PIMA COUNTY

ADDENDUM NO. 3

SOLICITATION NO. 202583 – SUNSET ROAD: SILVERBELL ROAD TO INTERSTATE 10

TP, DECK SECTIONS
SUNSET ROAD - SILVERBELL ROAD TO I-10
REVISION NO. TO P-30

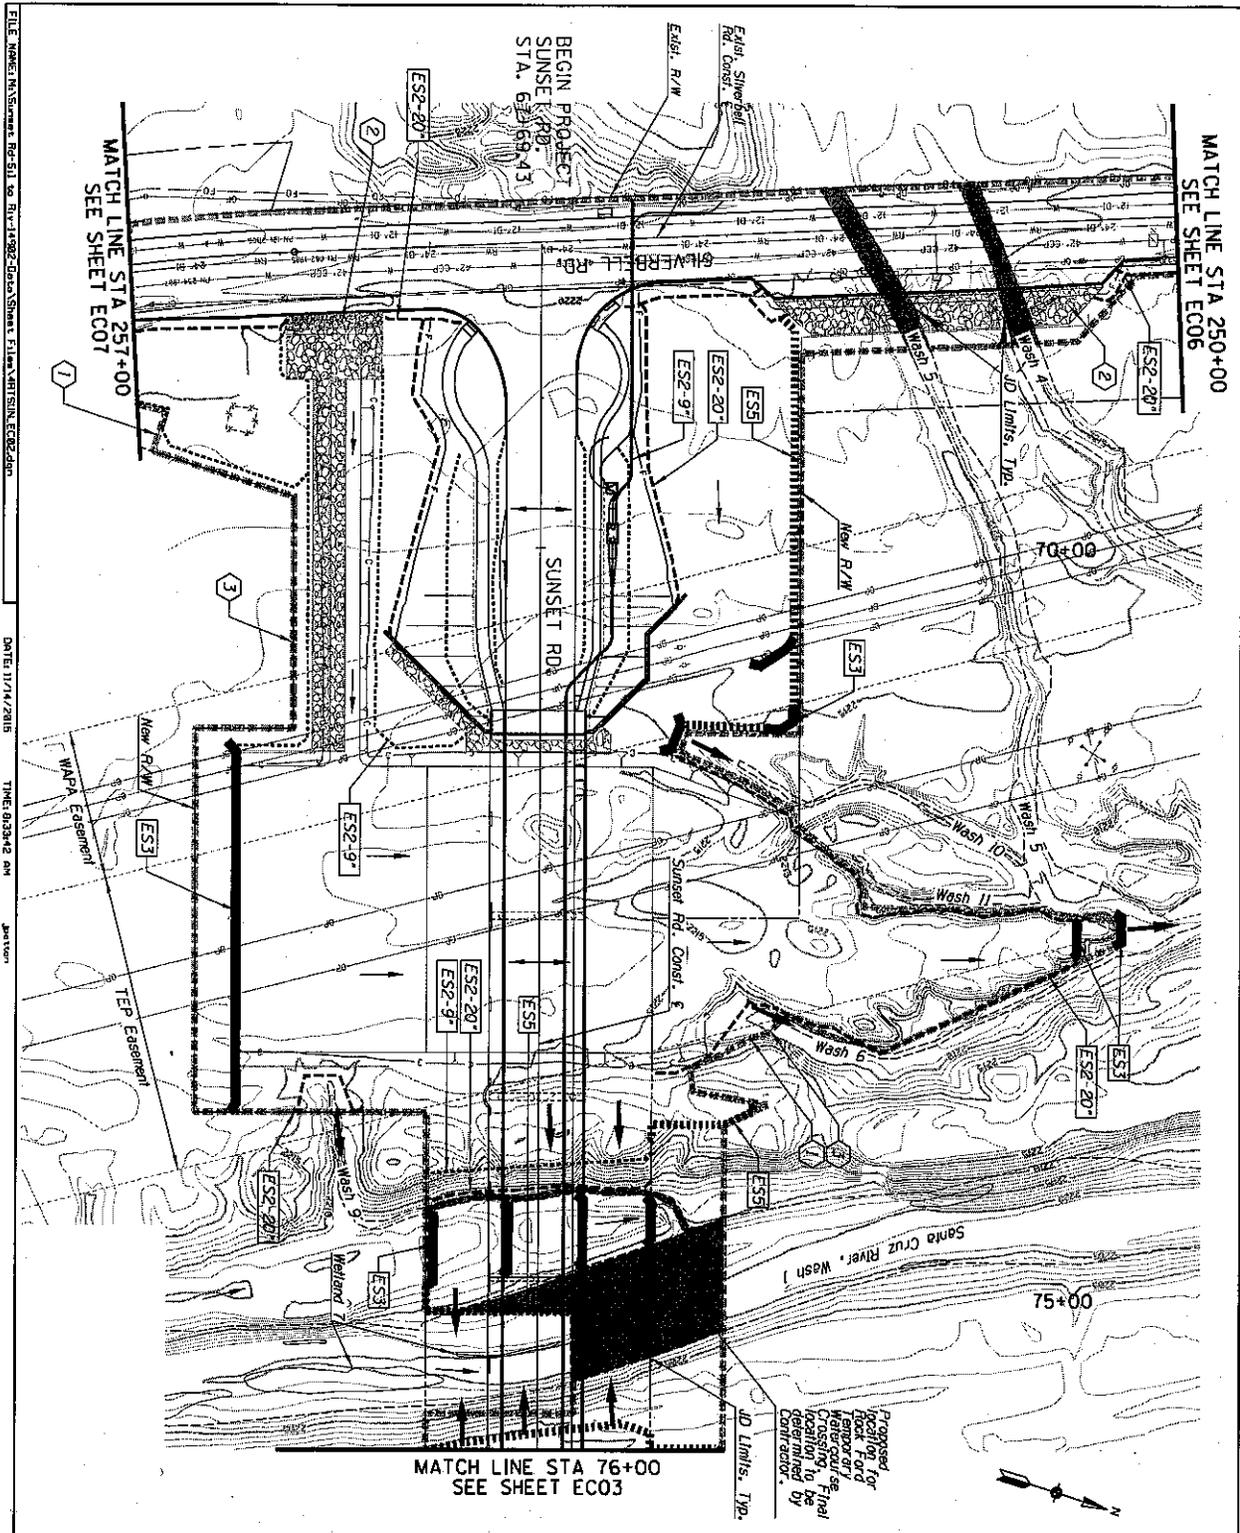
Q) Where there is restricted access due to the wetlands under span 4 (between piers 3 and 4), will stay in place deck forms be allowed?

A) Yes for that span only. Please see revised Sheet S23-Page 92 and new Sheet S23A-Page 92A Attachment 1 (2 pages)

No.	Revision Description	Engineer	Date	Drawn	Checked	Proj. Engr.	Date
1	S.L.P. Deck Span 4	C. Parinetti	1/28/18	AM	JMS/AR	AM	SCALE
				AM	CP	AM	SCALE
				AM	CP	AM	SCALE

EROSION AND POLLUTION CONTROL PLANS
STA. 244+74.07 TO STA. 250+00
SUNSET ROAD - SEGMENT 1
SILVERBELL RD. TO RIV
PROJECT NO. ARTSUN

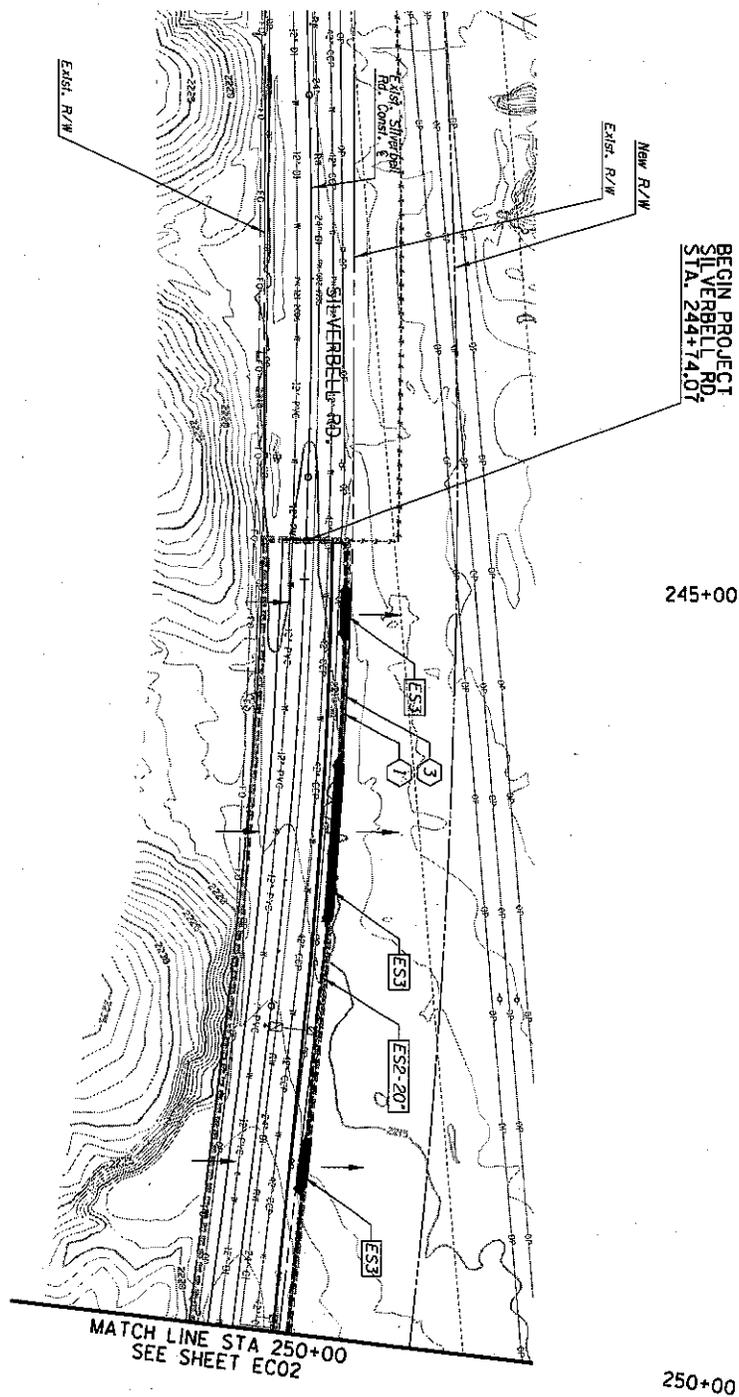
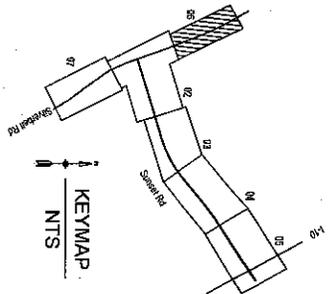
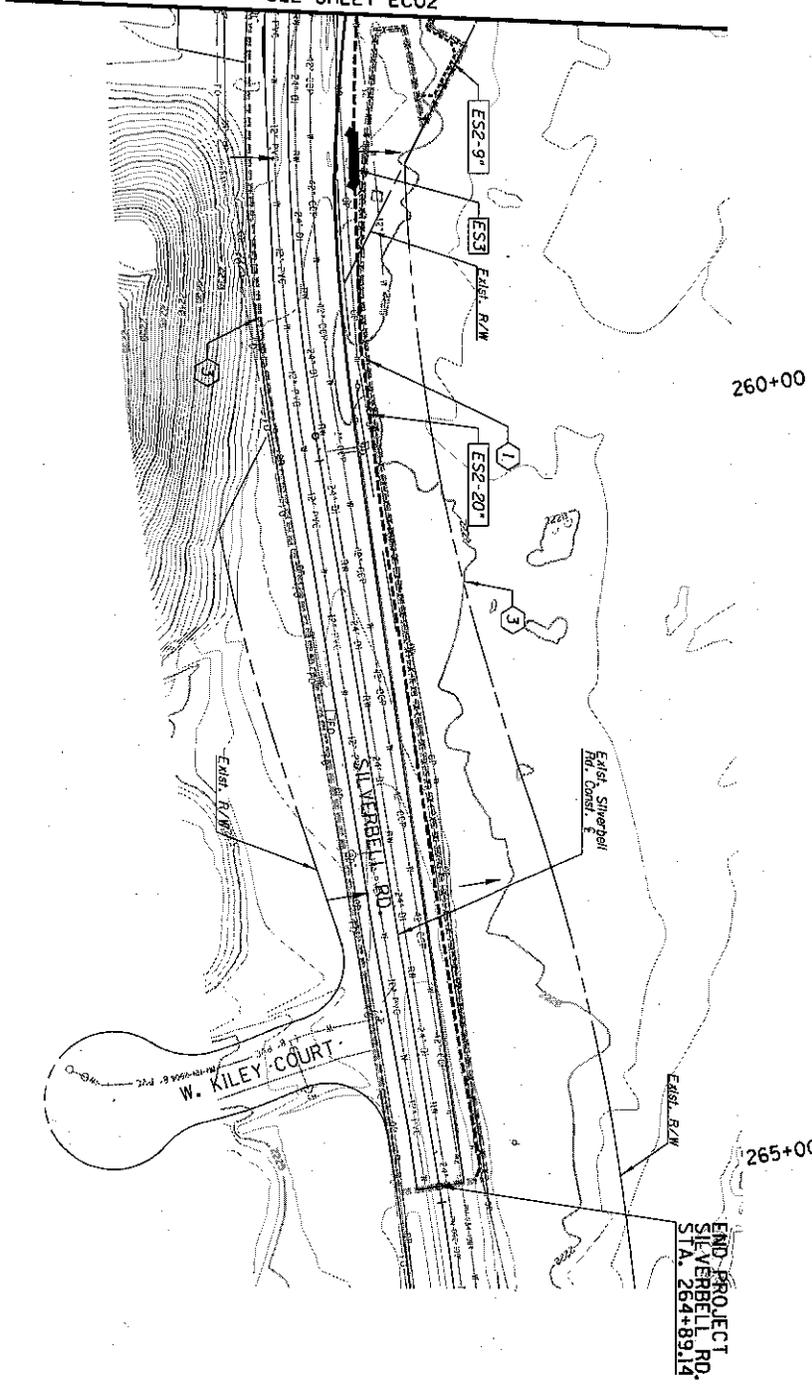
Q) Is there an electronic version of the disturbance limits?

A) Sheet EC02-Page 13 through Sheet EC07-Pages 140 depict the disturbance limits. A pdf version of the disturbance of those sheets is attached. Attachment 2 (6 pages)
